SUPPLEMENTAL INFORMATION REPORT

CHARLESTON HARBOR POST 45 PROJECT

US Army Corps of Engineers, Charleston District (USACE)

June 2018

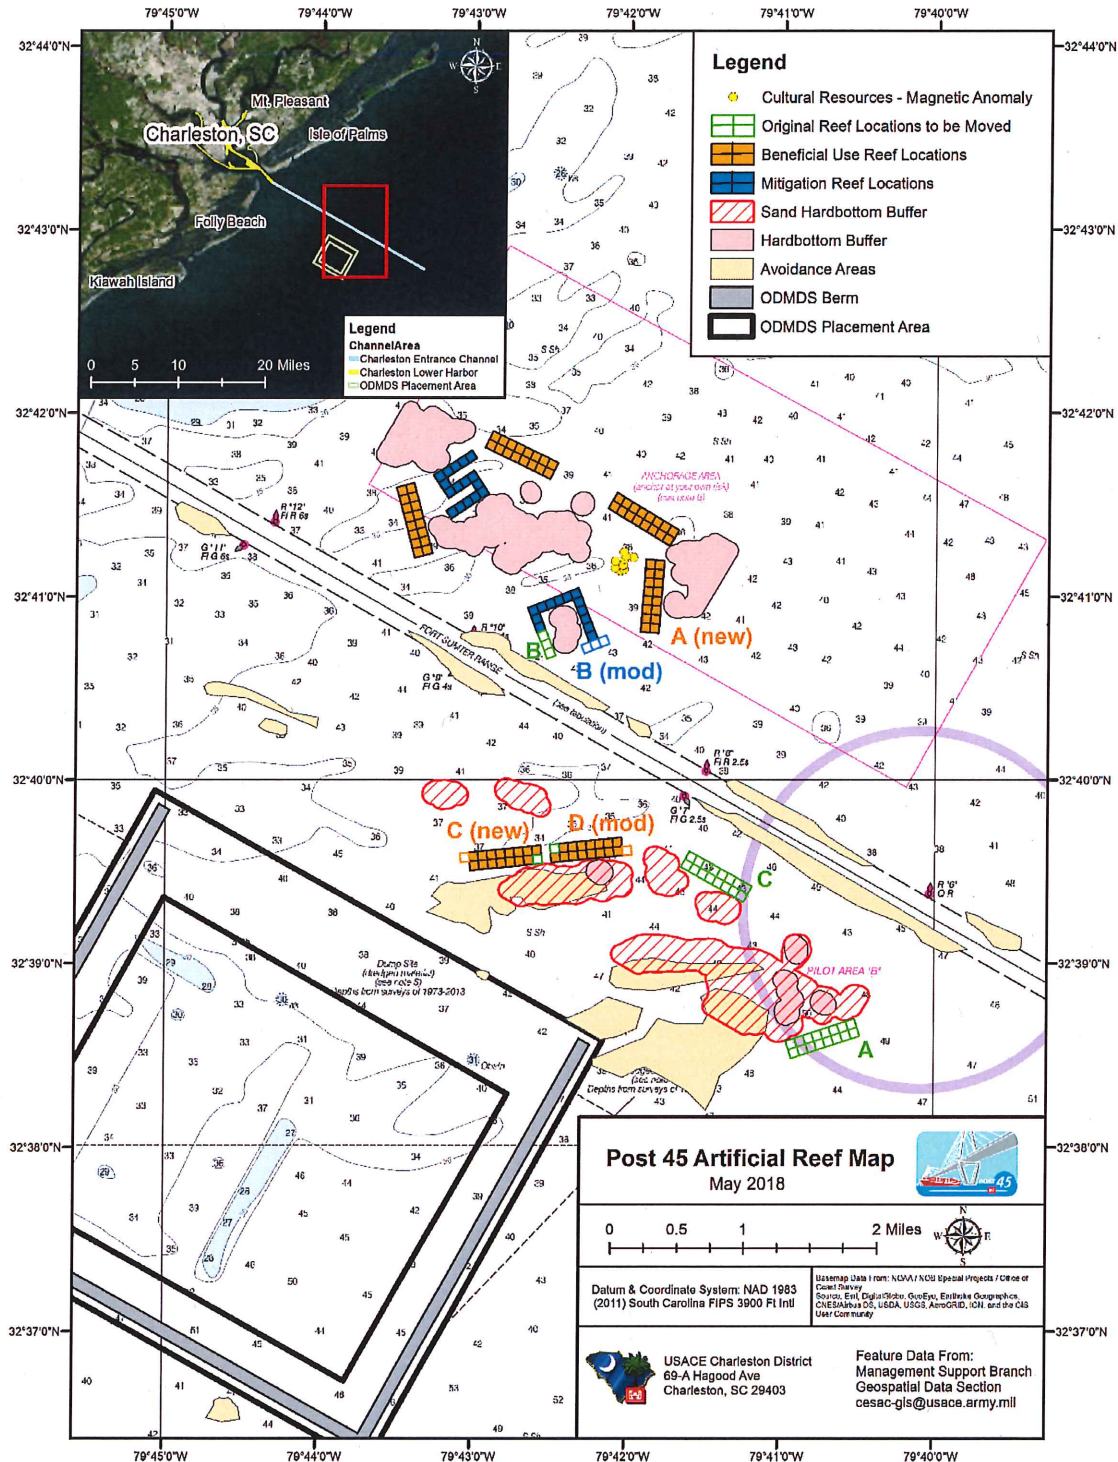
On 7 February 2018, the Charleston Branch Pilots' Association alerted the USACE that two of the beneficial reefs south of the entrance channel were sited for construction in areas that partially overlap with a charted pilot boarding area (Pilot Area B), presenting a "hazard" for the Pilots to board ships in this area. Additionally, the Pilots' Association expressed concerns about the proximity of the artificial reefs to the navigation channel, and the USACE confirmed that a small portion of one of the mitigation reefs fell within 1,000' from the entrance channel.

The modifications to the artificial reefs are depicted in Figure 1. Figure 1 shows the previously planned structure of the mitigation reef in question (labelled Reef B) and the new design modification, as well as the previously planned locations of the two beneficial reefs in question (labelled Reef A and Reef C), and the newly modified locations.

For the mitigation reef, three of the 300' x 300' cells that were less than 1,000' from the entrance channel have been shifted to the other side of the reef structure away from the entrance channel, in a location that still allows for edge diversity but doesn't interfere with existing hardbottom, cultural resources, or within 100' of another reef site.

For the beneficial reefs, the location of Reefs A and C have been modified to no longer overlap with Pilot Area B. Reef A has been relocated north of the entrance channel to an area that has already been surveyed for cultural resources and is in close proximity to existing hardbottom habitat. The size and shape of the reef has not been altered. Reef C has been relocated to the left of the other beneficial reef south of the entrance channel (labelled Reef D) that aligns an existing hardbottom area. Reefs C and D were reshaped slightly to ensure the reefs are at least 100' from each other. This involved moving one of the 300' x 300' cells to the opposite end of the reef to create sufficient clearance between the two reefs and the existing hardbottom. The overall size of Reef C has not changed.
